SERVICE INFORMATION

APPLICABILITY: 2014MY Impreza
2015MY Forester, WRX and WRX STI Models

NUMBER: 05-59-15

SUBJECT: Change to Front Strut Mounting Nuts

PART INFORMATION:

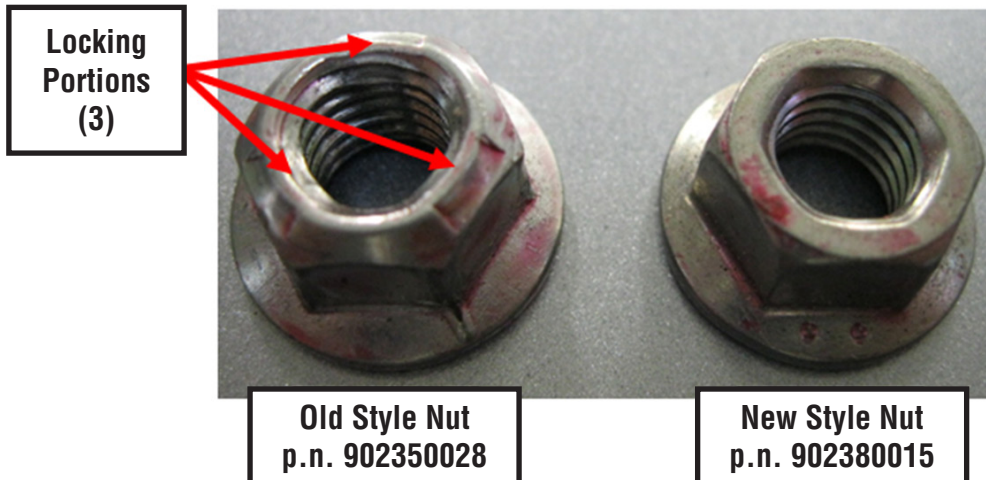
This Service Information bulletin announces a change to the flanged mounting nuts securing the front strut assemblies to the vehicle body. The change was made to enhance assembly line efficiency.

The Old Style flange nuts with 3 “locking portions” have been replaced by the New Style “smooth” nuts..

NOTE: The nuts are interchangeable between new and old but it is recommended to use all of one style or the other to maintain uniformity. The torque specification is unchanged (14.8 ft. lbs.).
